GROUP ENG	MODEL 2014~2015MY Cadenza (VG)
	NUMBER 148	DATE September 2015
<p align="center">TECHNICAL SERVICE BULLETIN</p>		
<p>SUBJECT: CHATTER/RATTLE NOISE FROM ENGINE AFTER COLD SOAK</p>

SUBJECT CHATTER/RATTLE NOISE FROM ENGINE AFTER COLD SOAK

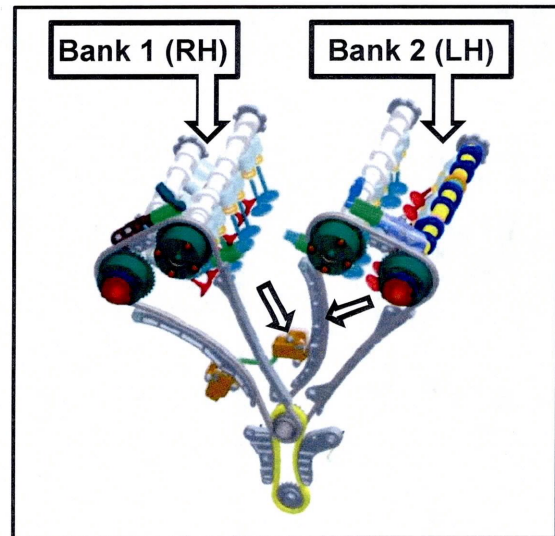
This Service procedure should ONLY be performed on engine bank 2 (LH), as shown.

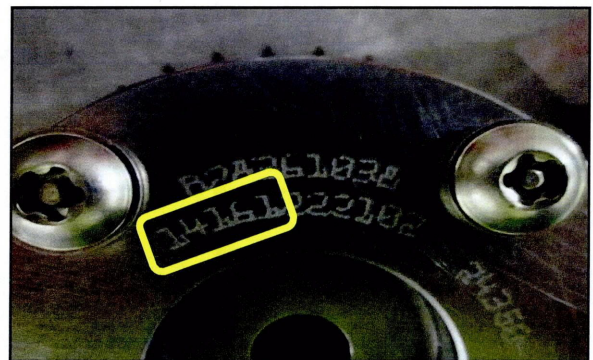
1. Refer to the "Engine Mechanical System → Timing System → Timing Chain" section in the applicable Workshop Manual on KGIS, to install the improved parts. **NOTE: prior to installation, refer to steps 2~4 for supplementary inspection/installation information.**
2. After removal of timing chain cover, inspect CVVT's on both engine banks to ensure the first five (5) digits of the eleven (11) digit serial number is equal or greater than "14111", on both Intake and Exhaust CVVTs. If the serial number is greater than 14111, proceed to step 4. If the serial number is less than "14111", replace the CVVT(s) prior to performing the remainder of this TSB procedure.

Additionally, inspect the replacement CVVTs to ensure the first five (5) digits of the serial number are greater than "14111".

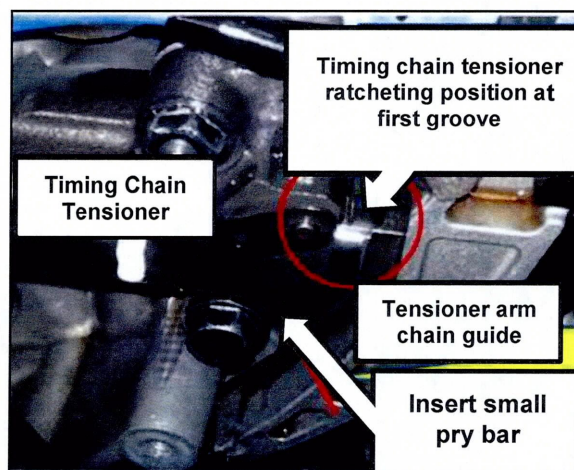
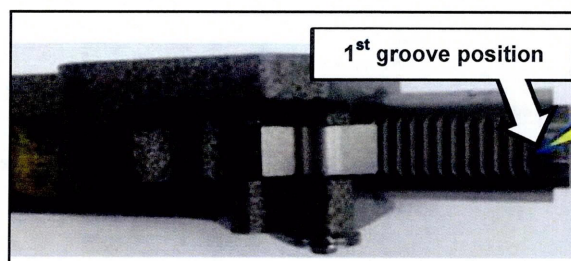
Prior to removing chain tensioners/adjusters, note position of the timing chain tensioner pawl to the rack grooves and count the number of teeth/grooves extending from the tensioner, as shown below. Make sure to record the count for later reference.

3. After installing the new tensioner, and timing chain guide, manually rotate the crankshaft three (3) full revolutions to securely seat the tensioner, then, check the number of grooves extending from the tensioner. When compared to the initial count, it should now be one (1) groove further out towards timing chain.

4. If after tensioner and guide replacement the tensioner pawl rack is not extended one tooth/groove further out than before the repair, use a small pry bar to extend the tensioner out one (1) tooth/groove further towards timing chain, as shown.

Do **NOT** extend the tensioner pawl rack out more than one tooth/groove or damage to timing chain may occur.
